NTD-NRC-94-4311
DCP/NRC0219
Docket No.: STN-52-003

SUBJECT: WESTINGHOUSE RESPONSES TO NRC REQUESTS FOR ADDITIONAL
INFORMATION ON THE AP600

NTD-NRC-94-4311
ATTACHMENT A
AP600 RAI RESPONSES
SUBMITTED SEPTEMBER 30, 1994

Figure 11.2-3 Schematic Showing Basis for PWR-GALE Code Modeling of Liquid Radwaste Flow Paths

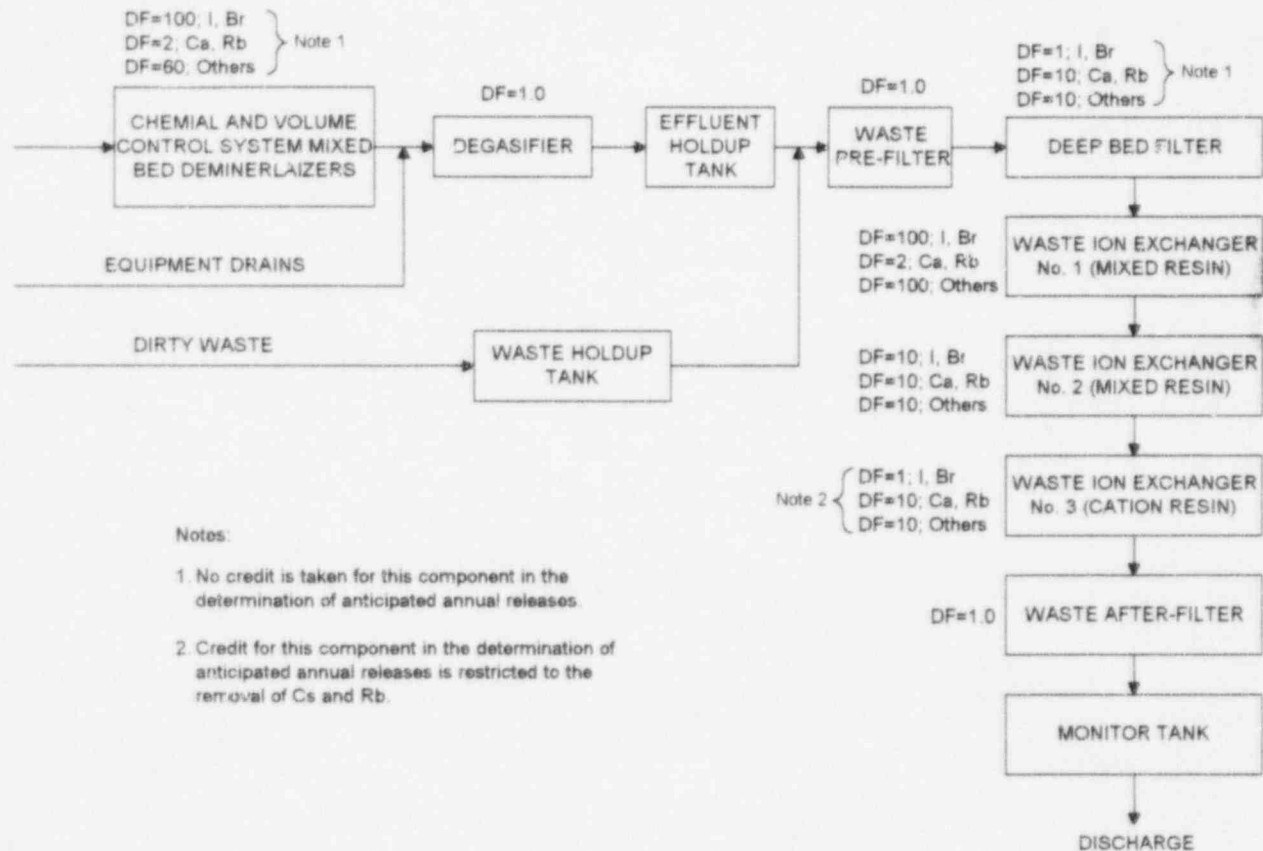
Provide schematics for the processing of the various liquid radwaste streams and explain how you have arrived at the decontamination factors (DFs) given in Table 11.2-6 of the SSAR for the different radionuclide categories in the various streams (Section 11.2).

NUREG-0017, Rev. 1, Figure 2-1 shows the purification demineralizers ~~upstream~~ of the shim bleed while Figure 11.2-3 of the SSAR shows the bleed downstream of the subject demineralizers. For the AP600, the starting point for radwaste processing for shim bleed, equipment drains and clean waste is the effluent holdup tank (see comment on Q460.9). Revise the schematic.

The attached figure contains a schematic showing the processing of the various liquid radwaste streams modeled in the analysis of anticipated releases to the environment. The decontamination factors for each of the radionuclide categories are from Subsection 2.2.18 of NUREG-0017, Revision 1. These decontamination factors are included on the schematic.

There is no discrepancy between the schematic showing the shim bleed passing through a chemical and volume control system mixed bed demineralizer and Figure 2-1 of NUREG-0017, Revision 1. The flow in question is the letdown flow but when the flow is diverted to the effluent holdup tank it can be called "shim bleed." In both the attached schematic and in the figure from NUREG-0017 the shim bleed flow passes through the chemical and volume control system mixed bed demineralizer before being diverted to the liquid radwaste system (or, in the case of NUREG-0017, to the boron recovery system). Although the starting point for cleanup of the shim bleed flow is actually the mixed bed demineralizer in the chemical and volume control system (and credit for this demineralizer was assumed in the original GALE code analysis), credit for this demineralizer is being deleted and a new GALE code analysis is being performed with the results to be included in Revision 2 of the SSAR. Also, as discussed in Revision 1 of the response to RAI 460.9, credit for demineralizer cleanup of the various waste streams will be limited to no more than a DF of 1000. For each of the waste streams shown on the schematic, the assumed cleanup will be:

The SSAR will be revised to include the schematic, which will be designated as Figure 11.2-3. The schematic has been revised since Revision 0 of this RAI response, to indicate that credit for the demineralizers will be limited as

discussed in Revision 1 to the response to RAI 460.9 and to reflect the elimination of onsite laundry. The first paragraph of Subsection 11.2.3.2 ~~will be~~ was revised in Revision 1 of the SSAR as follows:
